# RIDGE PORT 2ND ADDITION

RE: SUB 2001-93 -- Final Plat of Ridge Port Second Addition

**CASE NUMBER:** SUB 2001-93 -- RIDGE PORT SECOND ADDITION

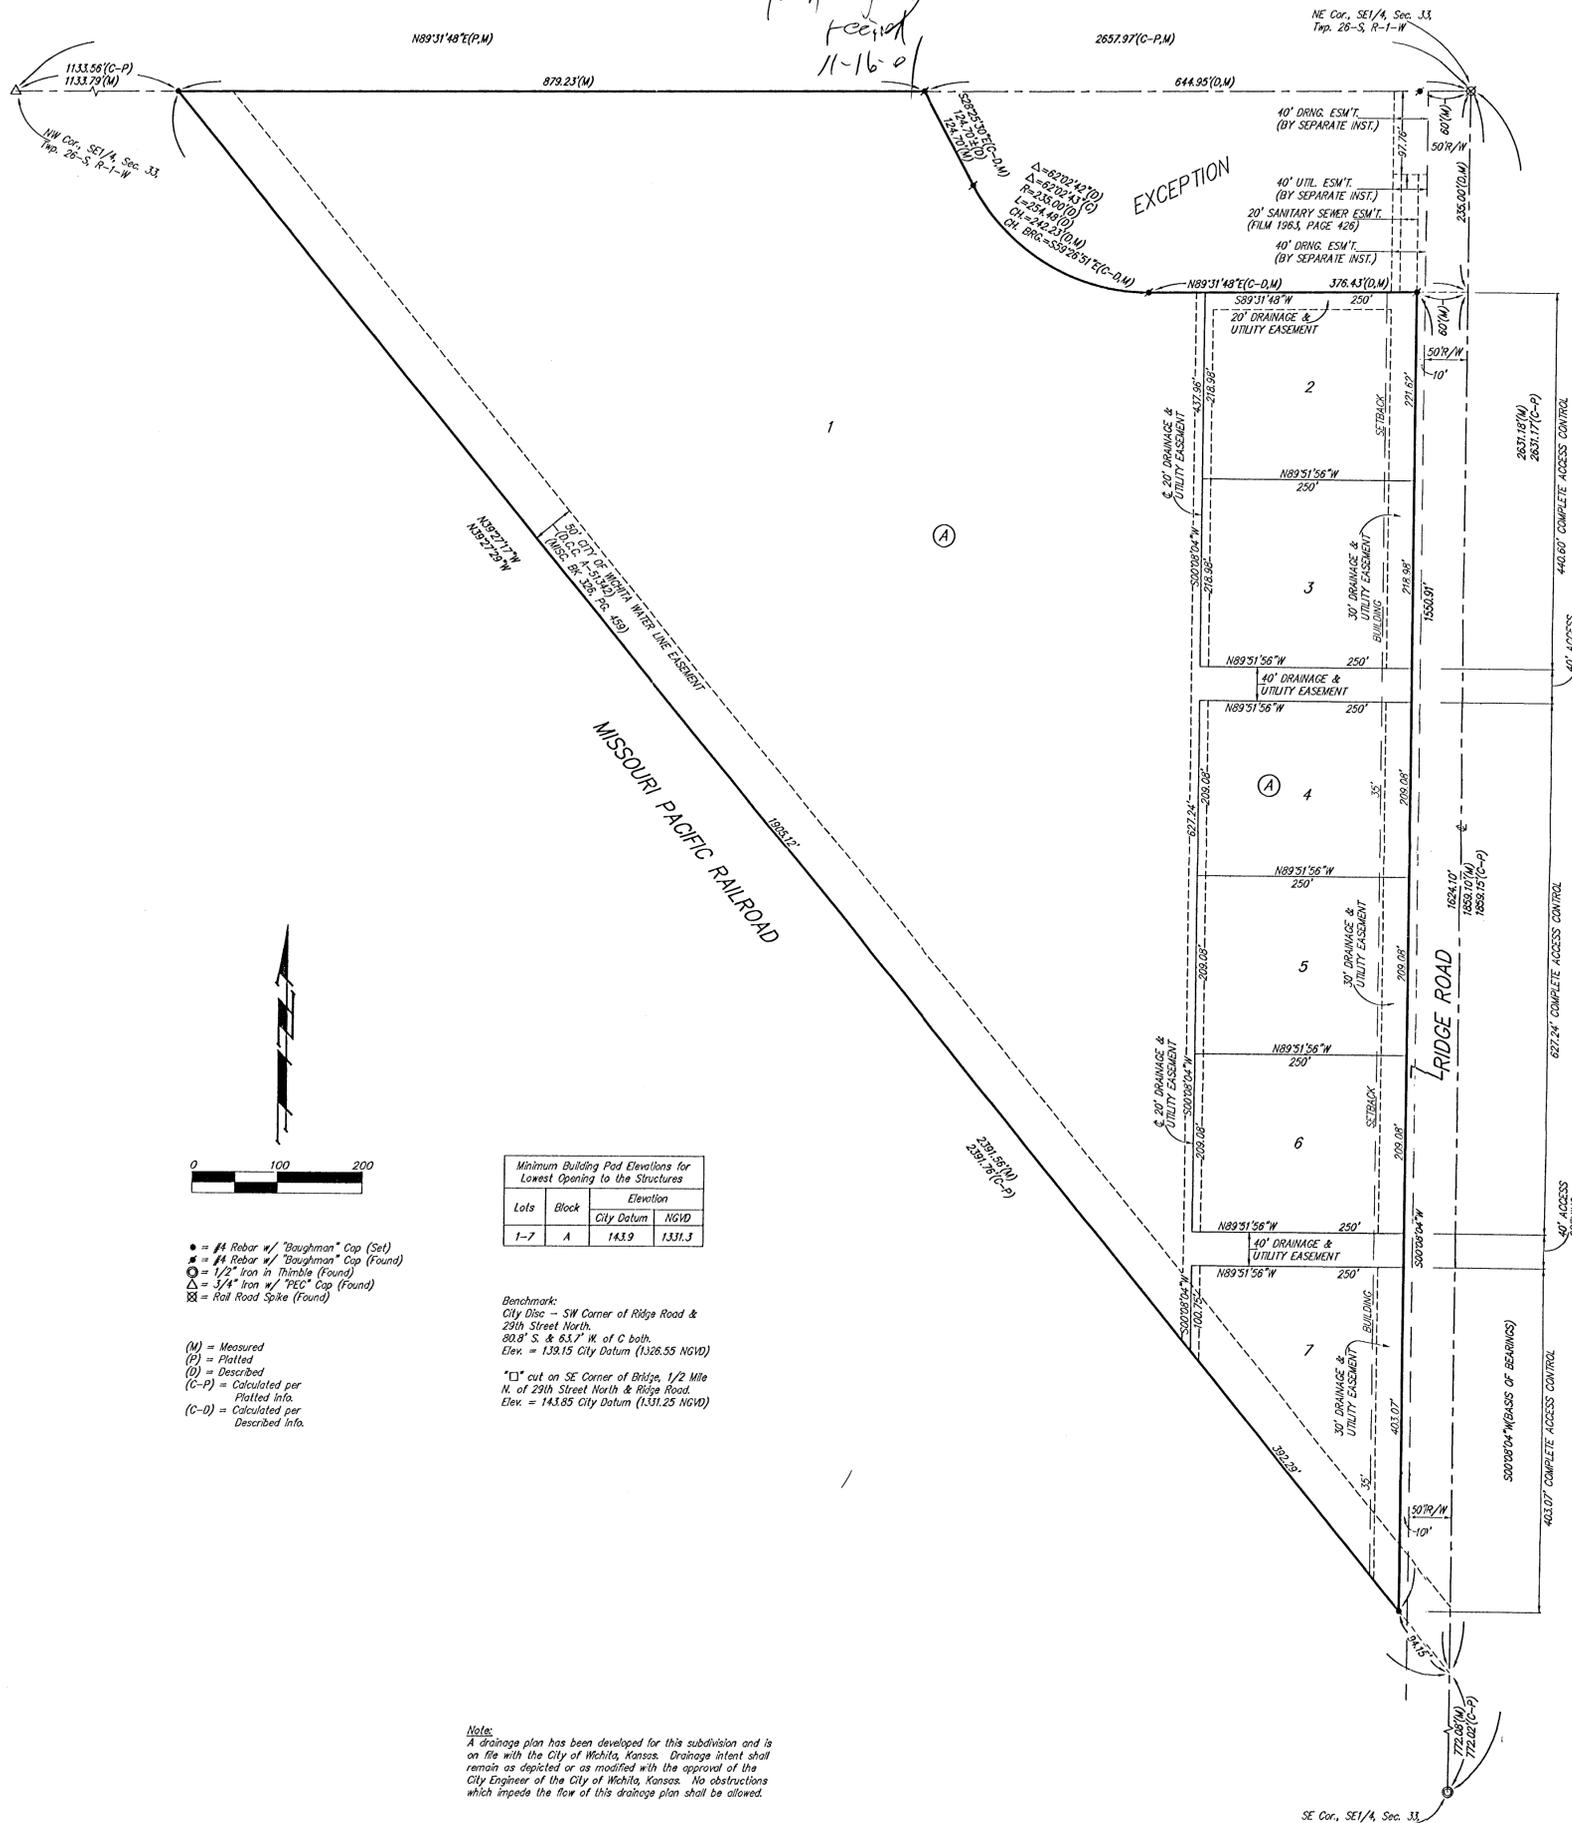
- A. The applicant shall guarantee the extension of sanitary sewer and City water to serve the lots being platted.
- B. **City Engineering** needs to comment on the need for additional guarantees or easements. *A petition for a sewer main is also required. The applicant shall meet with City Engineering to discuss the location of the sewer main. If located along the railroad, additional utility easement will be required.*

- D. **City Engineering** needs to comment on the status of the applicant's drainage plan. *The drainage plan is approved. A guarantee is required. An off-site drainage easement is required. A hydraulic analysis is needed as a part of the final drainage plan. County Engineering has requested a drainage plan.*

- H. The platlor's text shall include language that a drainage plan has been developed for the plat and that all drainage easements, rights-of-way, or reserves shall remain at established grades or as modified with the approval of the applicable City or County Engineer, and unobstructed to allow for the conveyance of stormwater.

**NOTE:** This is an unplatted site located within the City. In accordance with MAPC, the plat has been revised to reflect a relocation of the openings in alignment with the streets across Ridge Road, and elimination of the southernmost opening.

Note:  
A drainage plan has been developed for this subdivision and is on file with the City of Wichita, Kansas. Drainage intent shall remain as depicted or as modified with the approval of the City Engineer of the City of Wichita, Kansas. No obstructions which impede the flow of this drainage plan shall be allowed.
